Addendum #1

**Port of Port Arthur
Truck Queuing Area and Laydown Yard
Rider 37 Project 1 – CSJ 0920-38-288**

Addendum Date: August 21, 2025

THE SEAL APPEARING ON THIS DOCUMENT WAS AUTHORIZED BY JEREMY J. MITCHELL, P.E. 116941
7/31/2025 FIRM # 5755

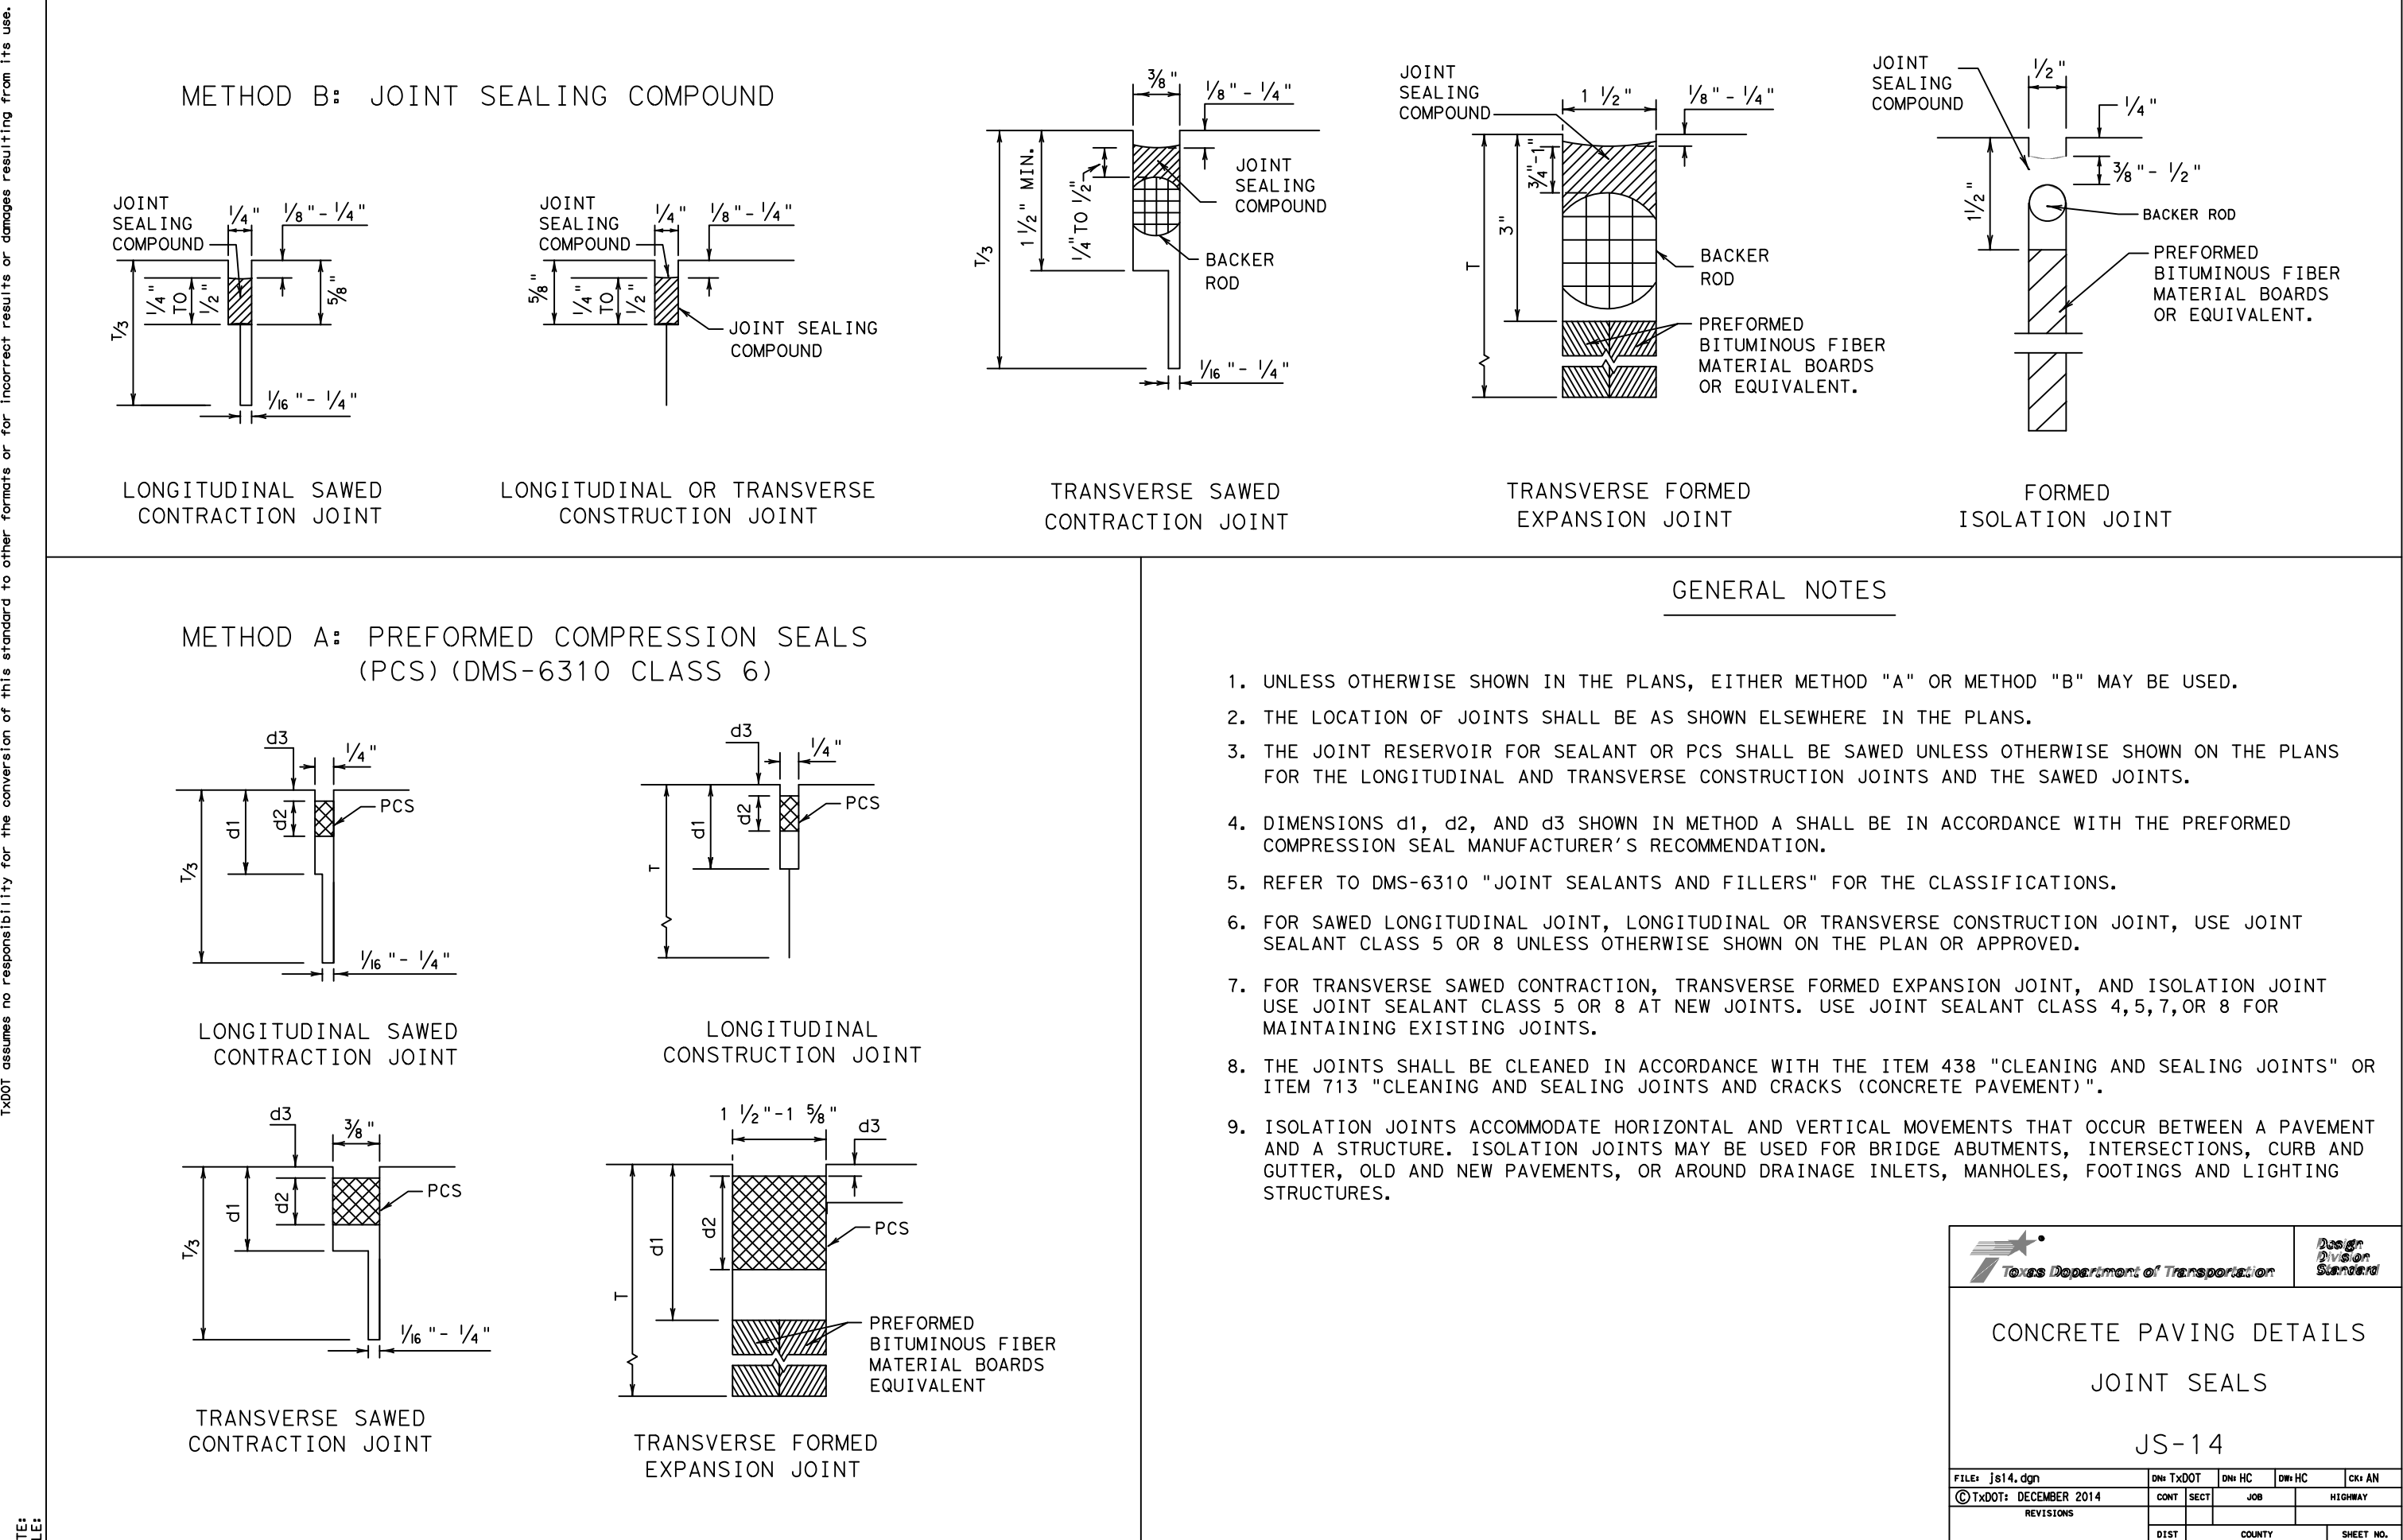
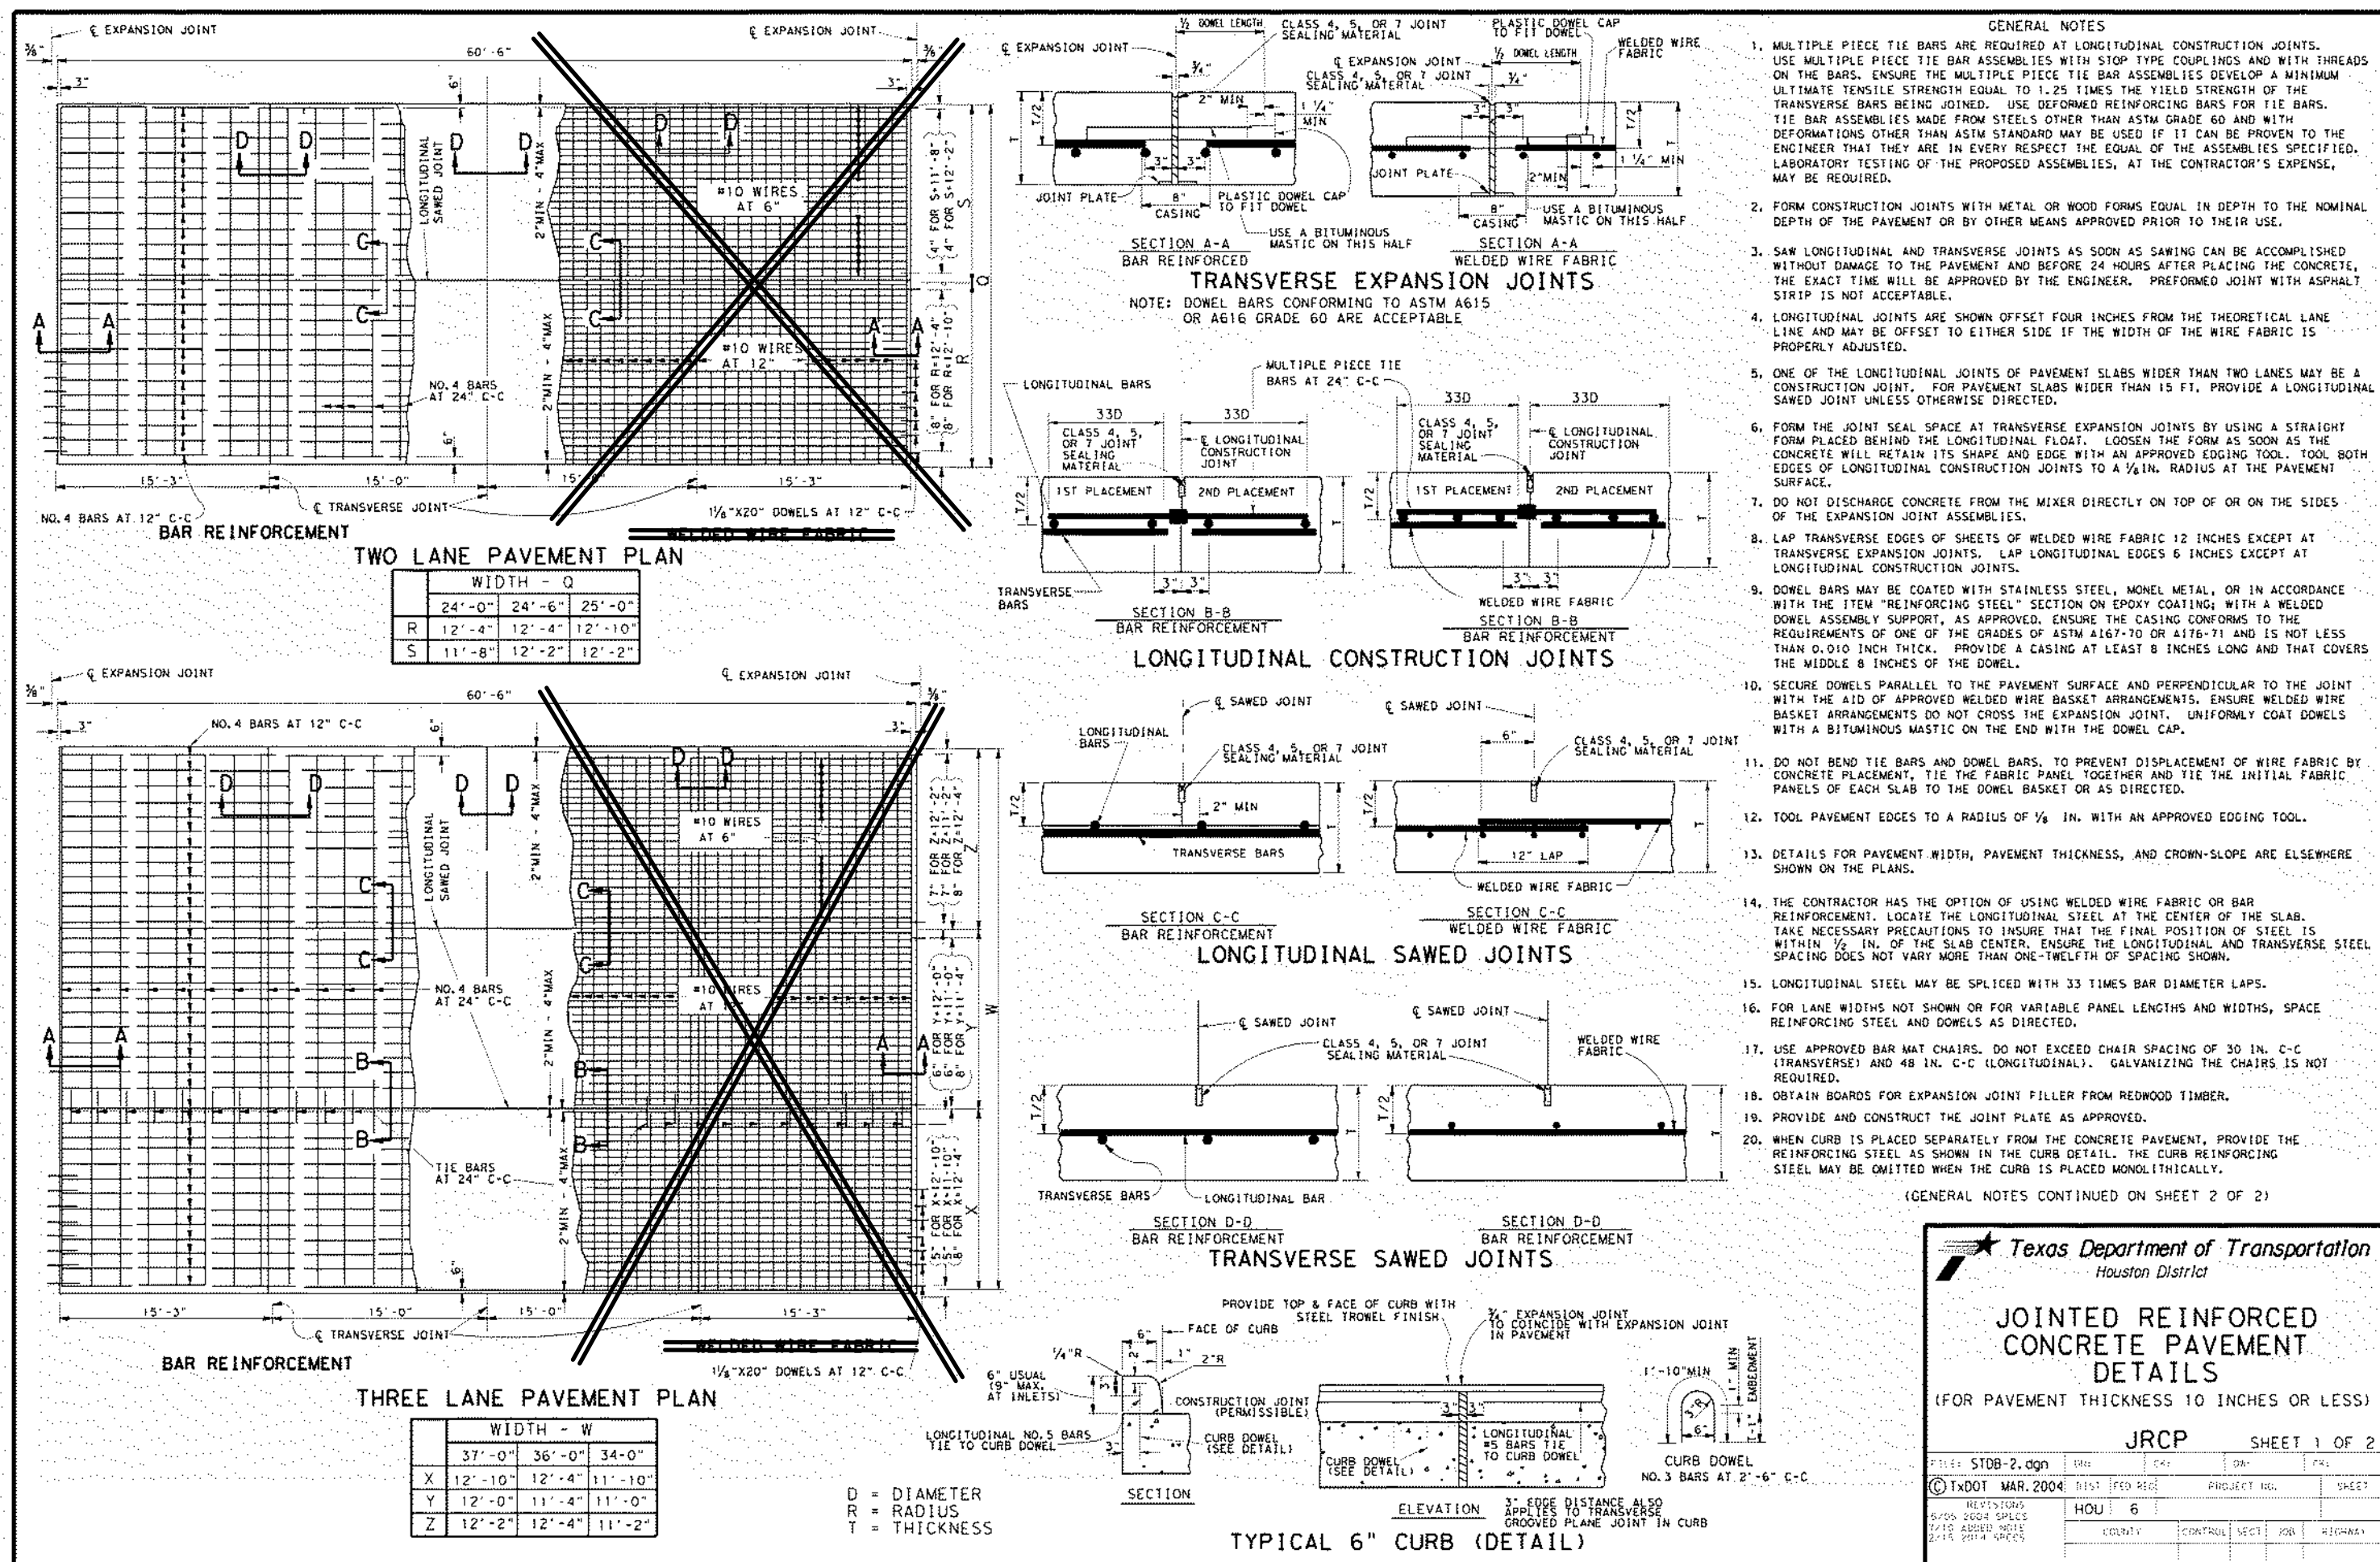
1. Bid items added (Demolition, Railroad Items, Traffic Control, etc.)
2. Steel casing around storm lines below rails, A36 standard wall thickness, smallest size necessary, no spacers. (30" steel on 24" hp, 24" steel on 18" hp) (sheet 8).
3. Rail work added to scope, remove and replace rails and ties (sheet 9).
4. Curb detail (sheet 13).

NO.	REVISION NOTES	DATE
1	ADDED CURB DETAIL	8/20/2025
